License Renewal Application

Requests for Additional Information (RAI) Responses for Severe Accident Mitigation Alternatives for Callaway Plant, Unit 1

Figure 2-1
GENERAL CET FOR NON-SBO SCENARIOS

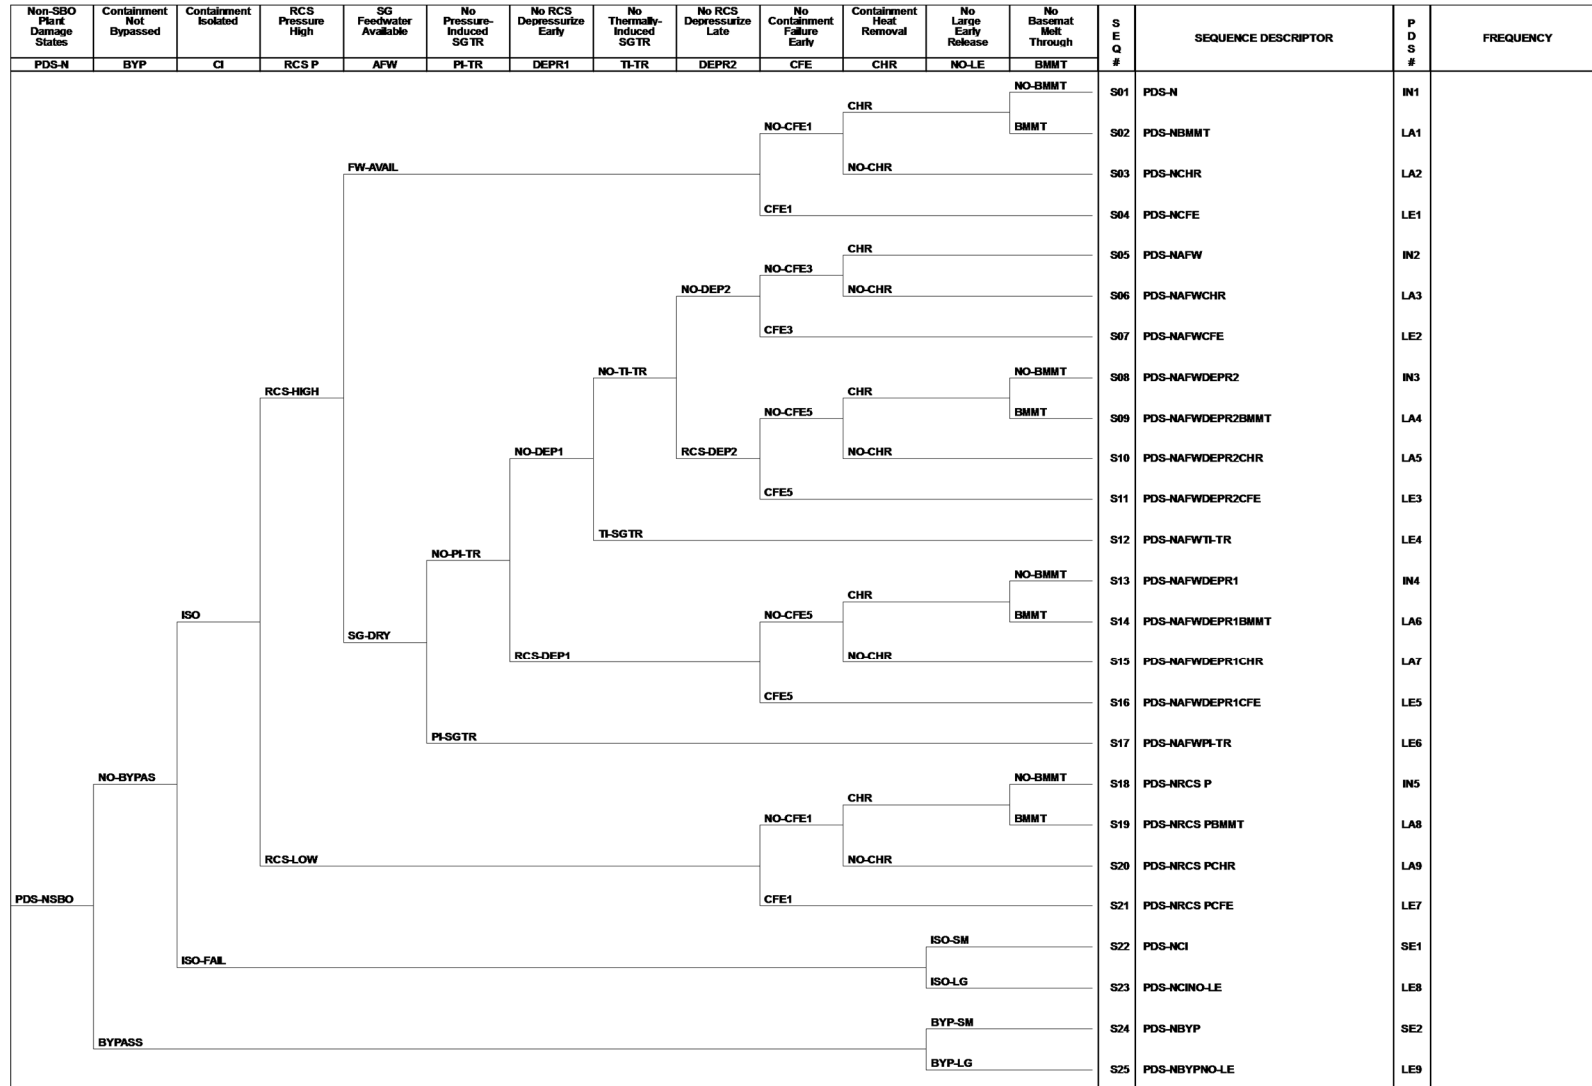
- c. Provide a description of the containment event tree (CET) or trees used in the level 2 analysis including a listing and description of the CET nodes. Include a description of how phenomenological events and containment system failures are addressed in the CET.

To assess the accident progression following a core damage event, this Level 2 analysis uses the containment event trees shown in Figures 2-1 & 2-2 based on the containment event trees provided in WCAP-16341-P. One event tree models station blackout scenarios, while the other models all other events. The event trees begin with one or a group of core damage sequences, then ask a number of questions to determine the type of release, if any, that occurs. Each question is modeled as a top event in the event tree and the outcome is based on previous work for Callaway, recent accident progression research, and the guidance provided in the WCAP. Each top event in the event trees is discussed below. Endstates on the event trees are discussed in Sections 2.4 and 2.5.
